**08-AFC-8**

HECA project

**AIR Data Request Number One**

Association of Irrigated Residents  
Tom Frantz, President  
30100 Orange St  
Shafter, CA 93263

**Comparison of Number of Violations of 8 hr Ozone Standard**

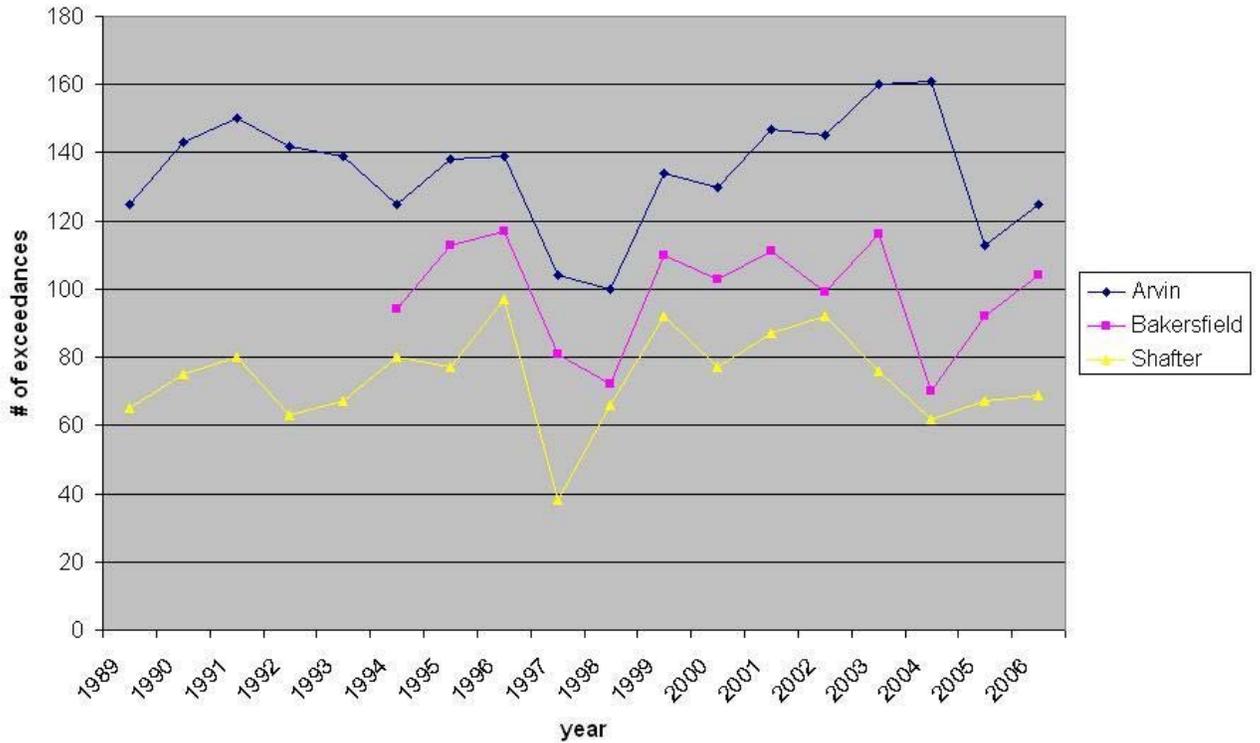
The Shafter ozone monitor does not provide a conservative representation of the ambient air quality. Shafter ozone measurements are relatively low compared to Bakersfield and locations southeast of Bakersfield. The HECA site is influenced heavily by the oil fields to the west and northwest of the project site. Prevailing winds push pollutants from some of these oil fields directly towards HECA. Many of the highest emitters of criteria pollutants are upwind of HECA including nearby Aera Energy and Chevron operations. Shafter is downwind of farmland for the most part. It would be more relevant and more conservative to use the Arvin monitor readings for ambient ozone measurements in the southern part of the San Joaquin Valley. Arvin is downwind from the HECA sight and is downwind from the oilfields north of Bakersfield. The ambient air around Arvin would be more similar to the ambient air around the HECA sight. Since Arvin has the highest ozone readings in the southern San Joaquin Valley it is also more conservative and precautionary to use it for ambient air readings instead of Shafter which actually has the lowest ozone readings in the area. The graph below shows the differences between Arvin, Bakersfield, and Shafter in the

number of violations of the 8 hr ozone standard annually from 1989 to 2006 before the standard was lowered from .80 ppm to .75 ppm last year.

- **Data request no. 2**

Is there any reason not to do the air analysis using the measurements of the nearby monitoring stations (in Kern County) showing the highest numbers for the relevant criteria air emissions?

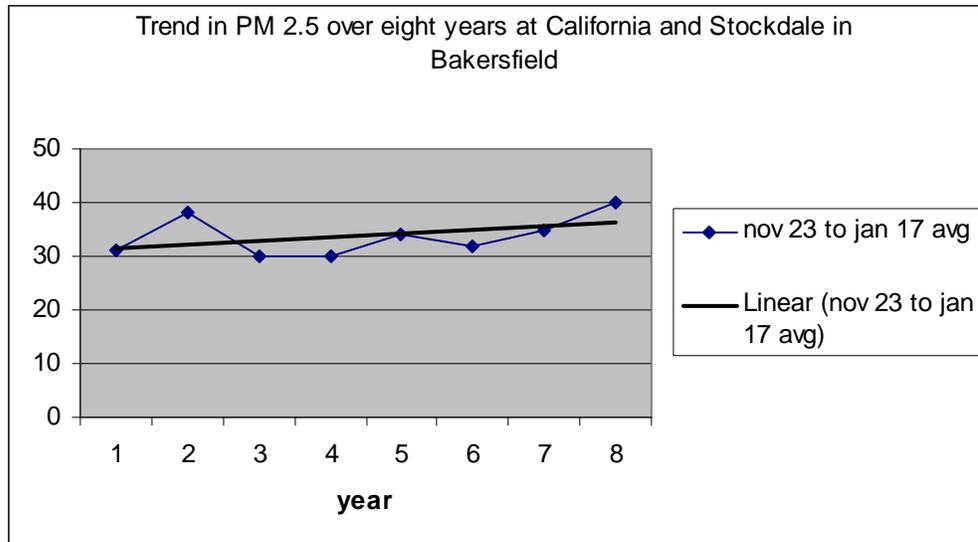
Some clarification is needed on the local situation. The biggest source of local PM 2.5, which is the most predominate and harmful winter time air pollutant in the southern San Joaquin Valley, is the mixing of ammonia and NO<sub>x</sub> to form ammonium nitrate. Most of the ammonia comes from agricultural sources and levels of ammonia have increased greatly in Kings, Tulare, and Kern Counties with the tremendous growth of the dairy industry in these counties the past eight years. For example, both Kern and Tulare have seen an increase of over 150,000 milk cows the past eight years. With calves and support stock the increase in total livestock is far higher. This increase in ammonia levels coincides with a gradual increase in PM 2.5 levels at the California and Stockdale monitor over this same period of time. It is important to note that progress has not been made in this problem of PM 2.5 the last six years at this particular monitor in spite of NO<sub>x</sub> reductions from vehicle fleet turnover and in spite of the restrictions that have been put on both residential and agricultural burning over this period. The reason for this lack of progress needs to be examined carefully before large new sources of pollutants are introduced to the region from the HECA site. Especially, the rationale the air district uses to justify SO<sub>x</sub> emission reduction credit trading to mitigate PM 10/2.5 emissions must be re-examined. The air district contends that regulating or decreasing ammonia levels would not decrease PM 2.5 so they only regulate NO<sub>x</sub> and SO<sub>x</sub> and this is the justification for the interpollutant trading. They claim that since ammonia is in surplus over NO<sub>x</sub> that it would do no good to decrease ammonia levels. But, this is contradicted by Bakersfield PM 2.5 growth the past six years. The air district needs to explain this contradiction or anomaly in their PM 2.5 plan.

The graph bellows takes the average reading for the eight week period from Nov 23 to Jan 17 for eight years in a row. The regression line shows a clear and gradual increase in these averages. The last data point is for the eight week period from Nov 2008 to Jan 2009.

Clearly something is wrong with the local air district plan to come into compliance for the PM 2.5 federal standard. Just as clearly, the added PM 2.5 from this plant will interfere with the steady progress that needs to be made but is not being made towards compliance with this federal standard. It is not legal, therefore to trade SO<sub>x</sub> etc's from 20 years ago, or more, for PM 10/2.5 emissions.
